# **ADDENDUM NO. 1**

## **Middle Georgia Regional Airport (MCN)**

**PA PN 20202946.0003**

Issued: June 16, 2023

SHEET:  
**EA-204**

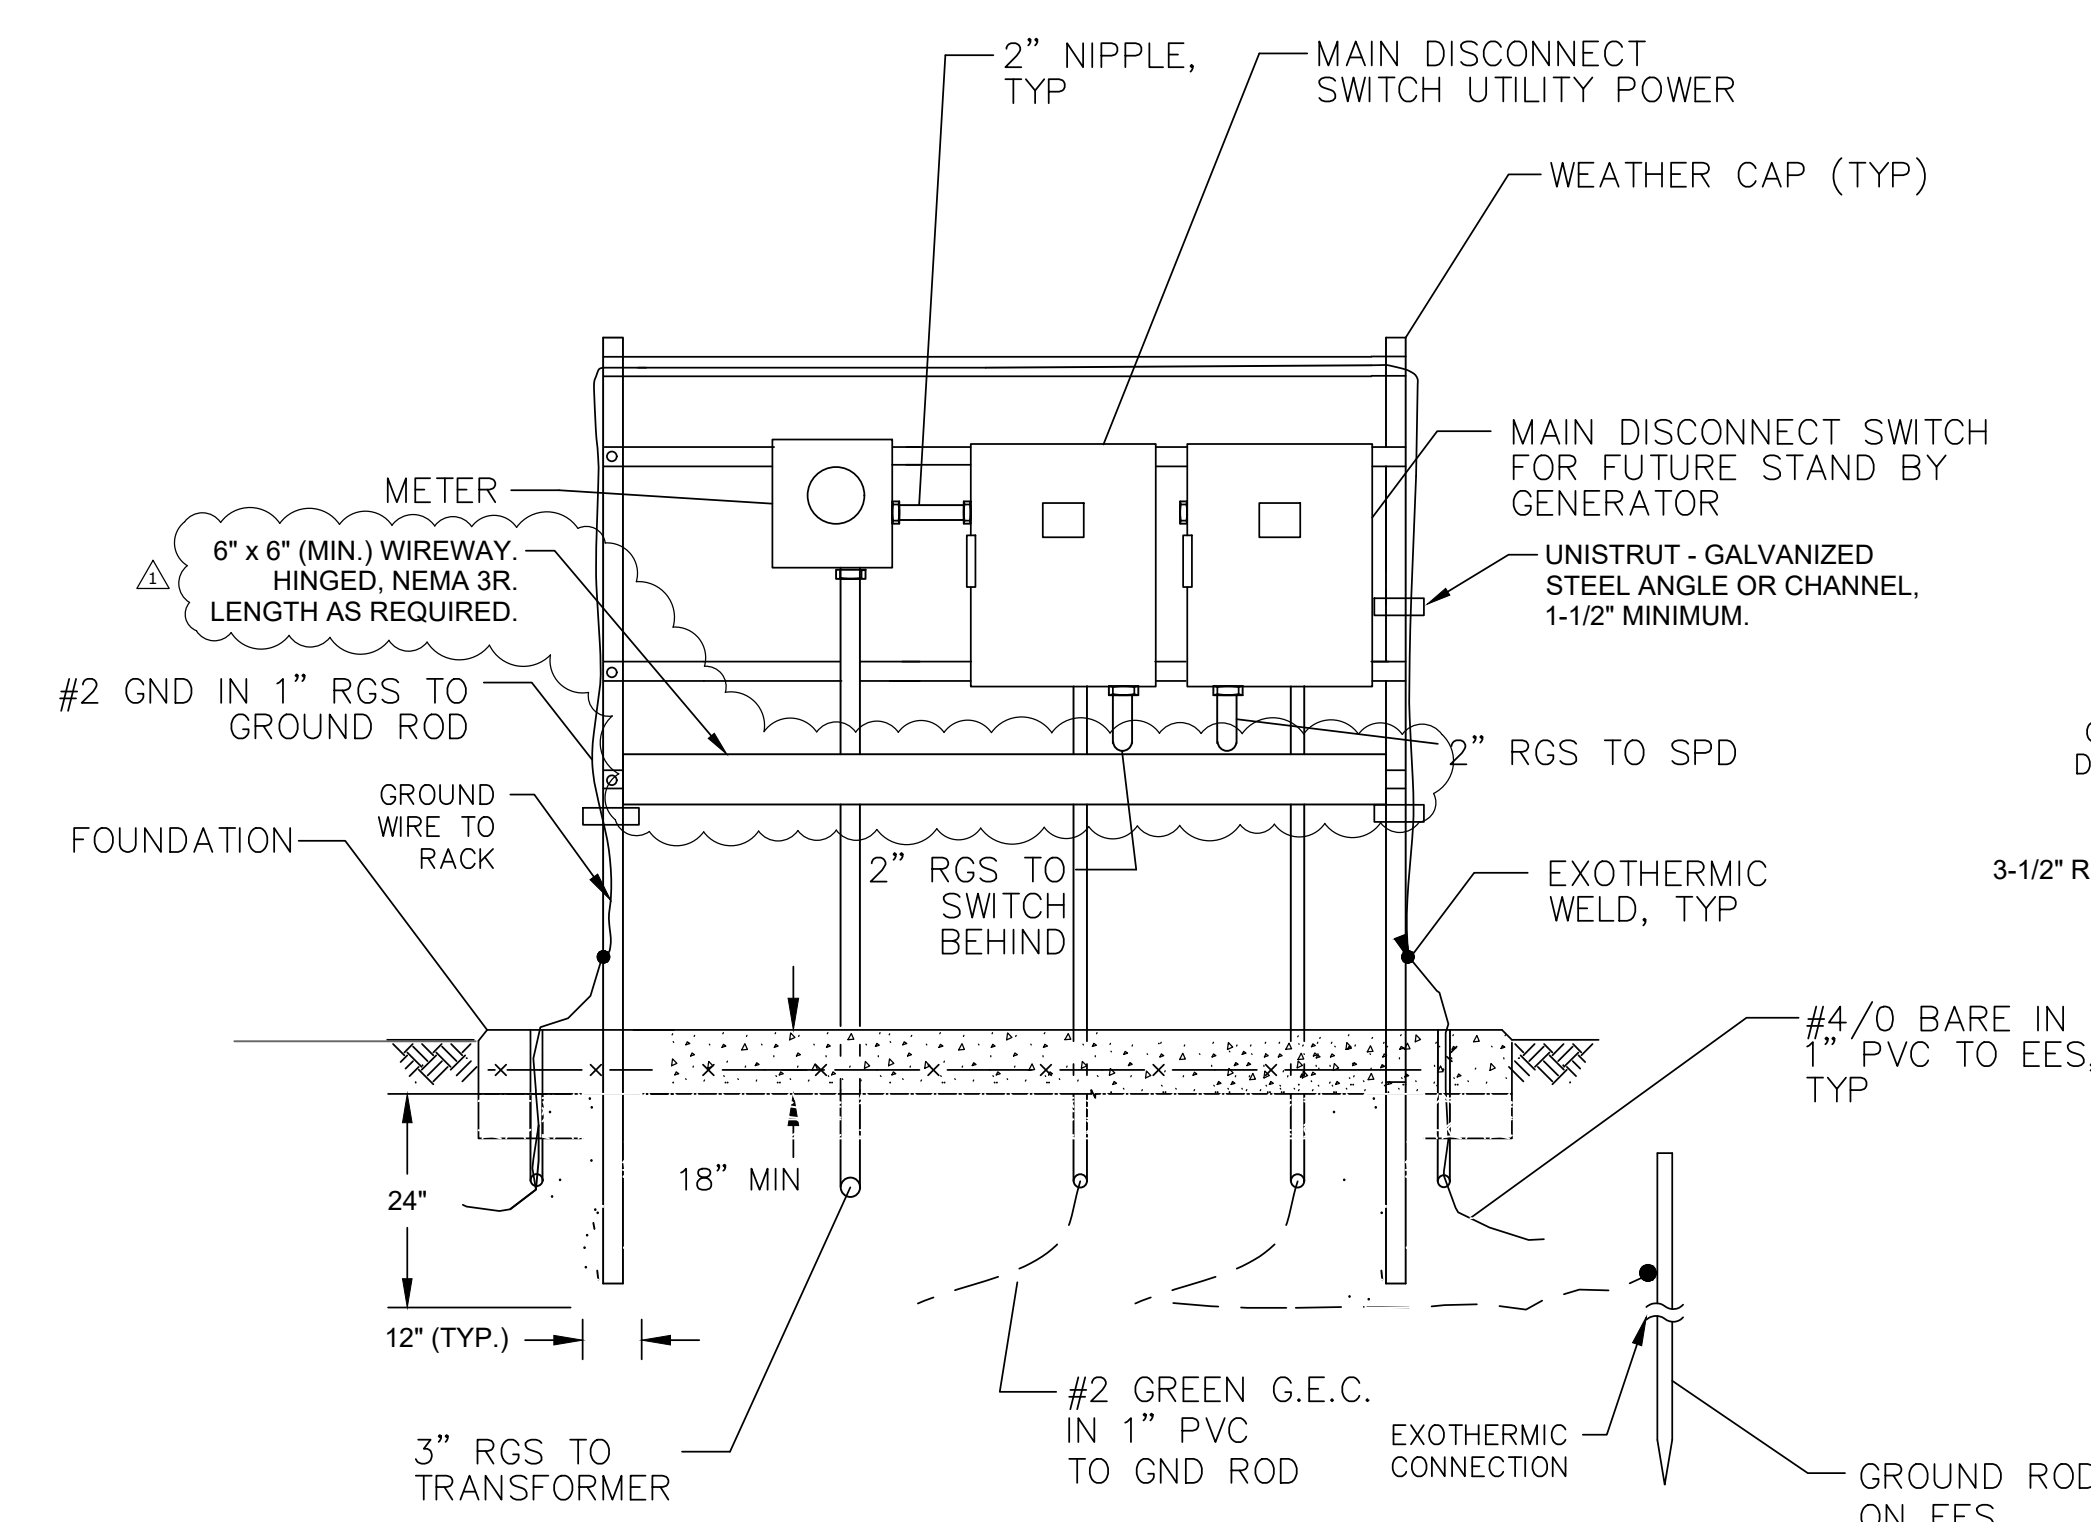
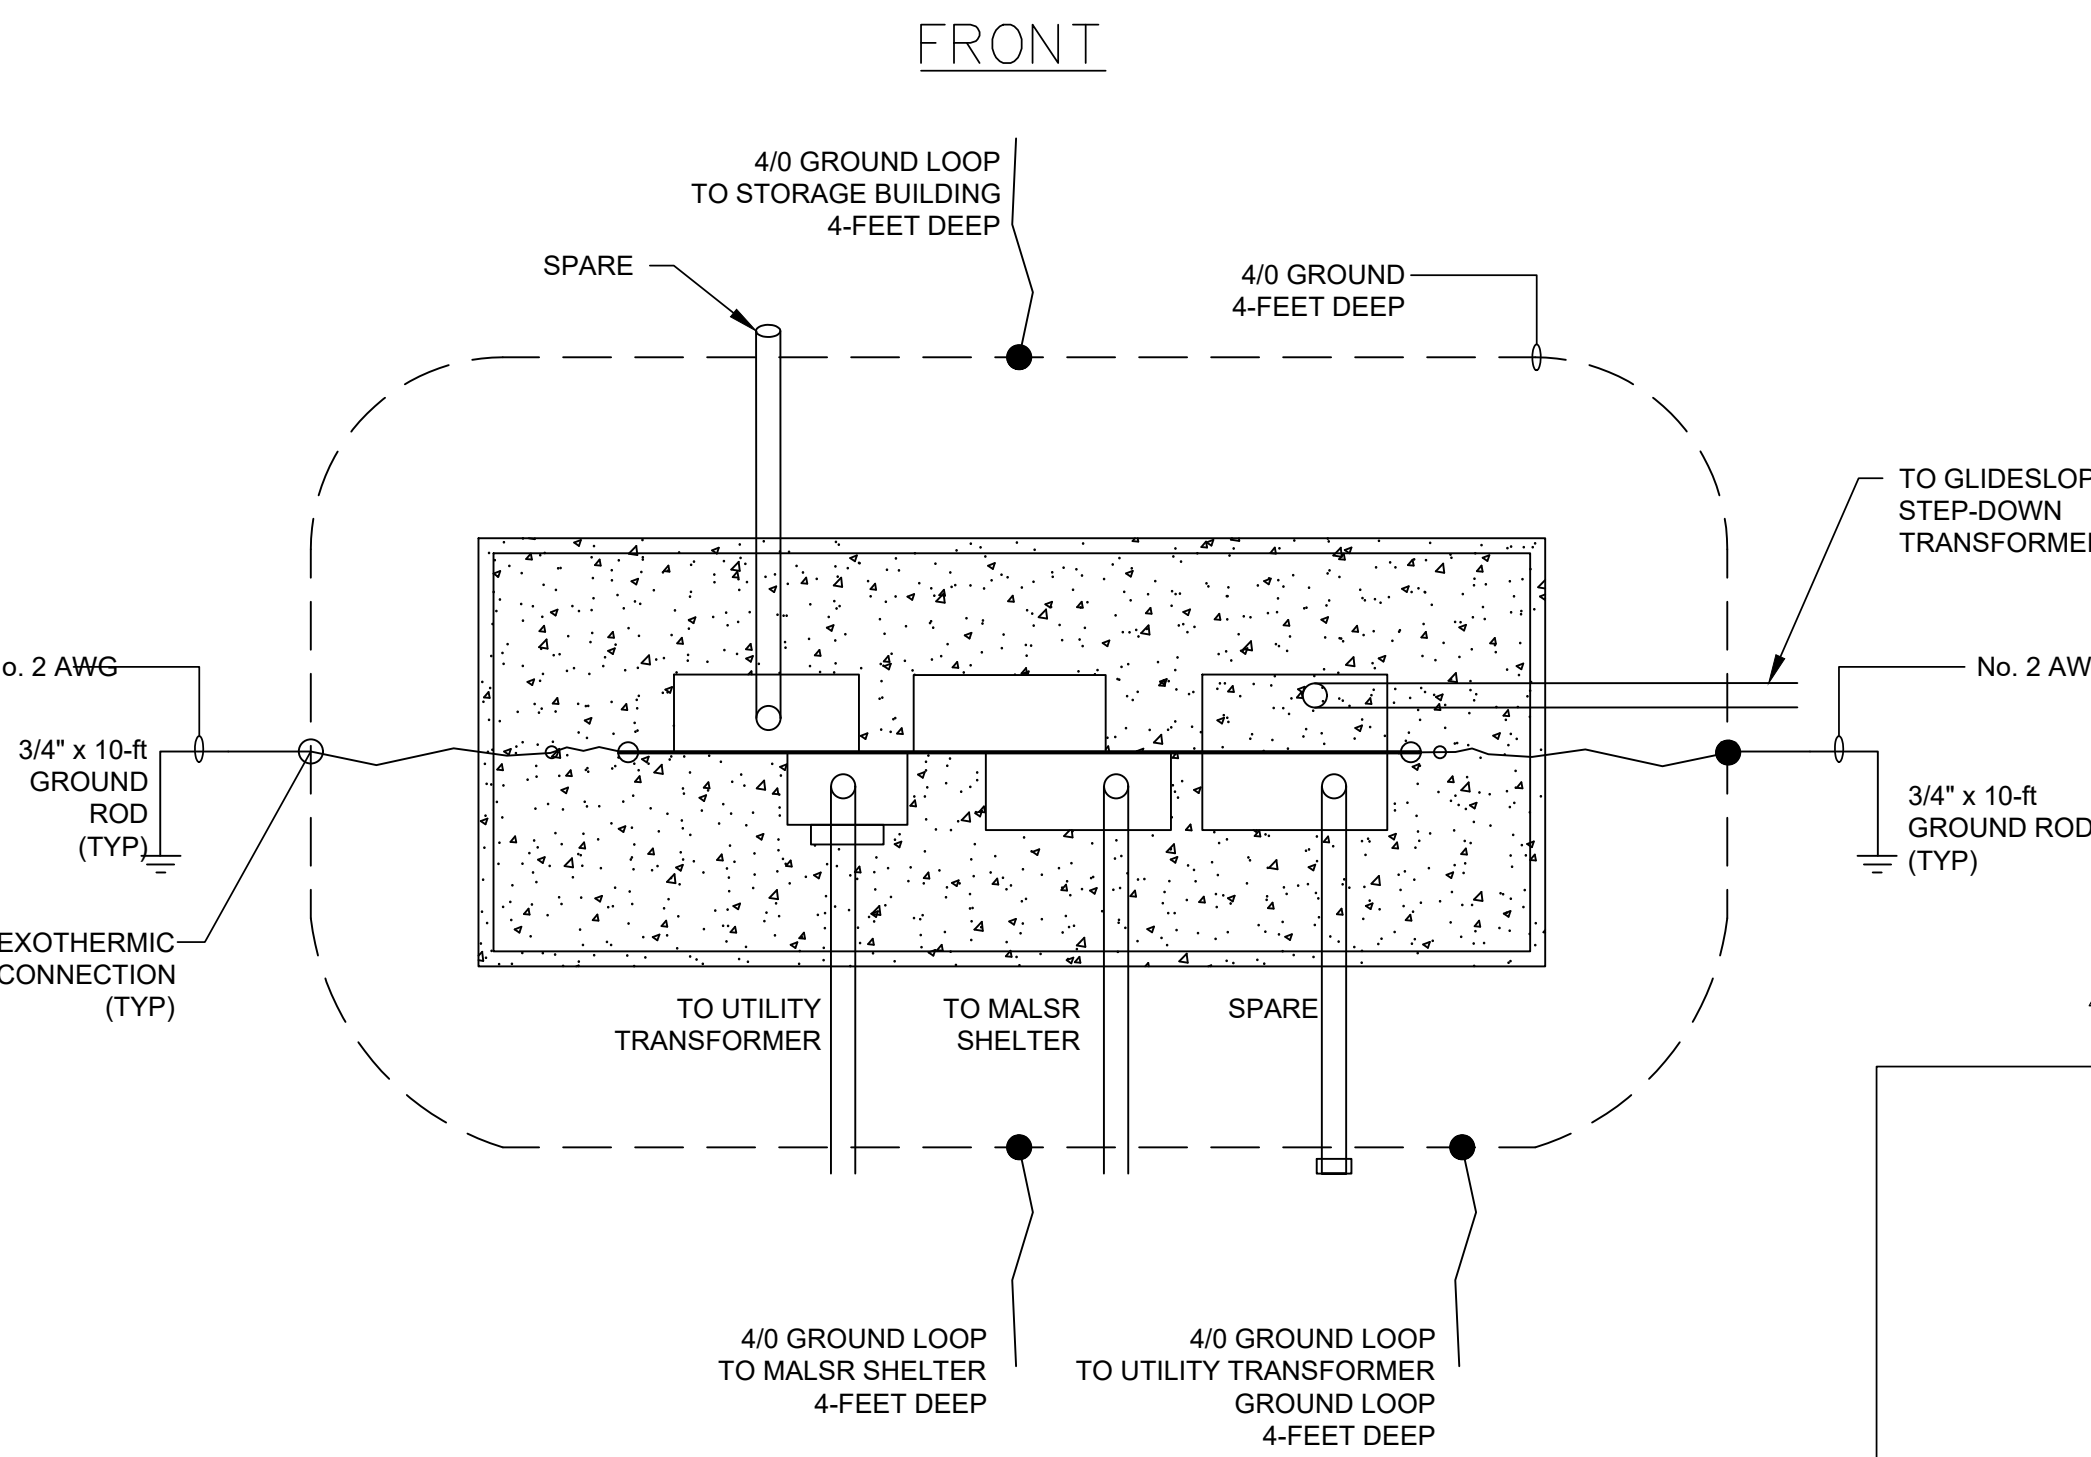
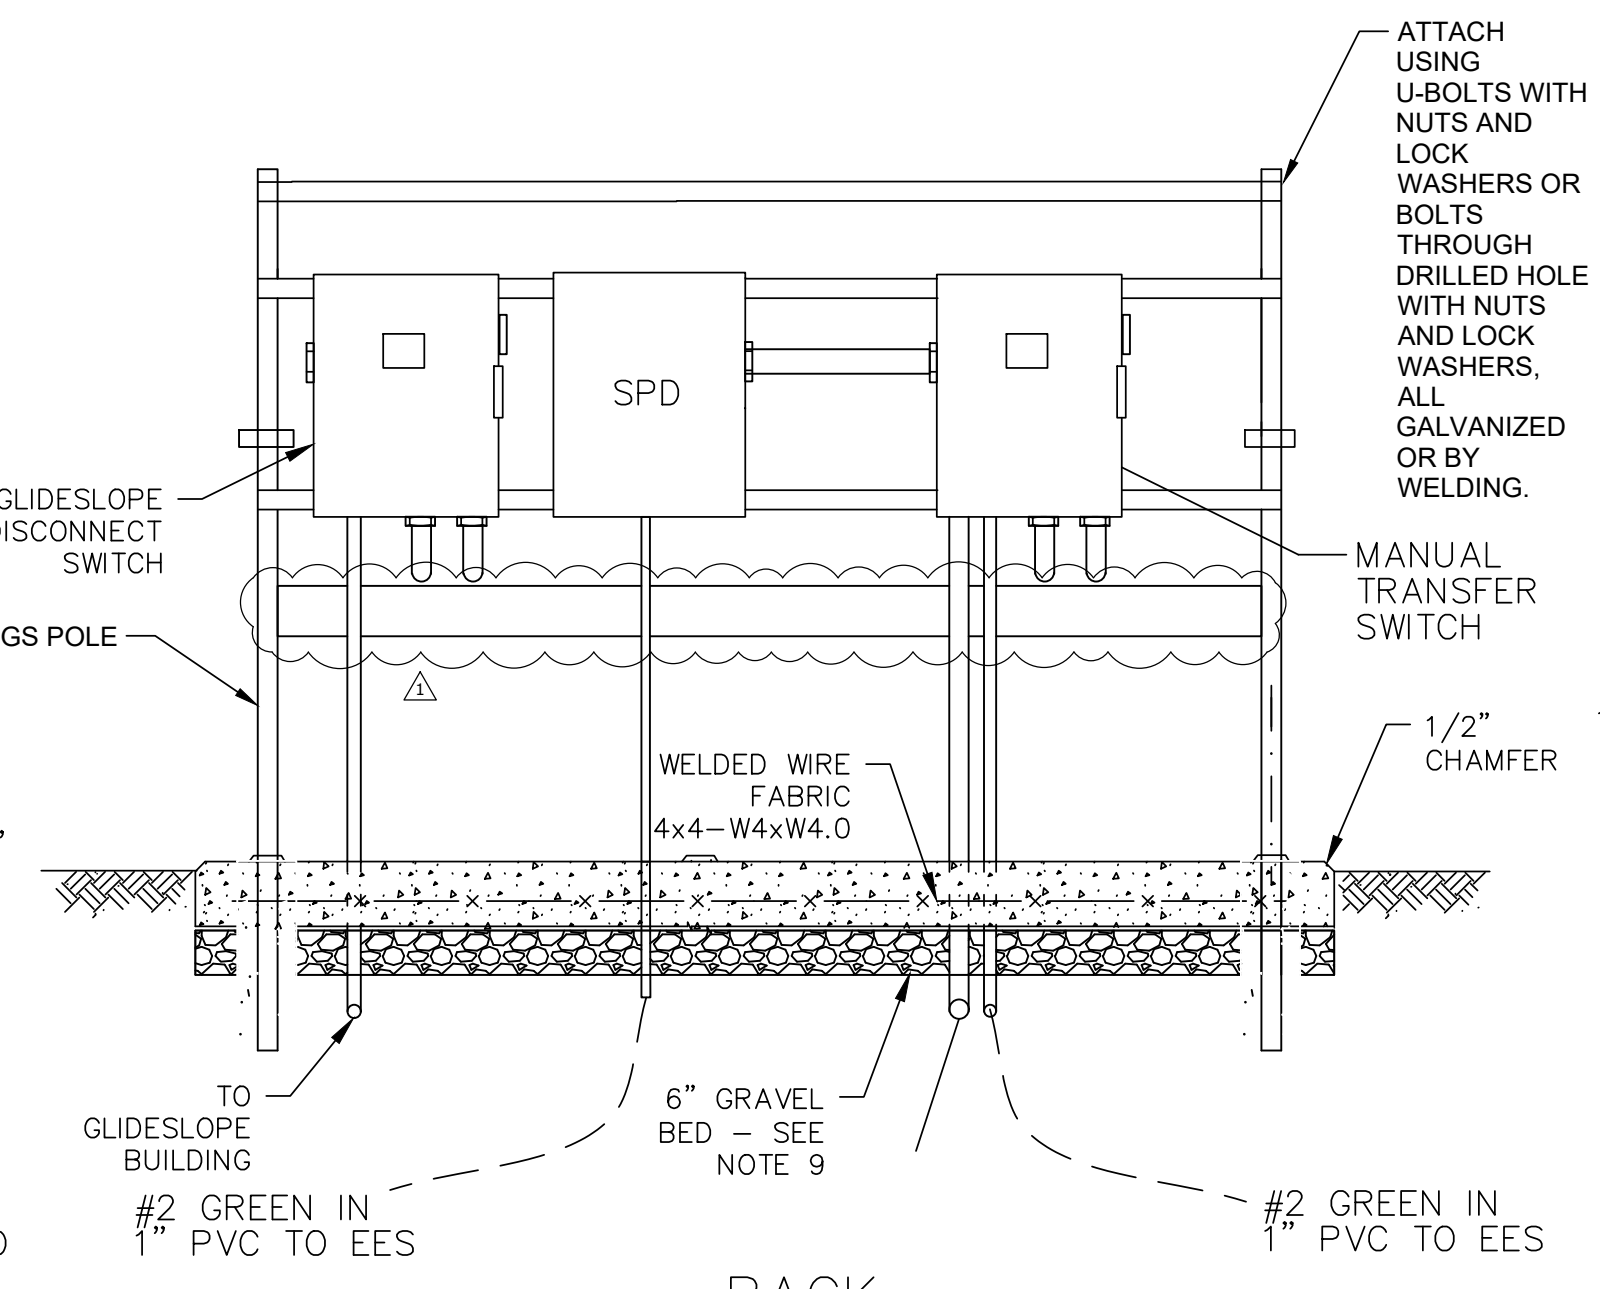
**REPLACE** electrical sheets with revised, attached sheets, EA-001, EA-101 through 103, EA-203, EA-204, and EA-301 through EA-304.
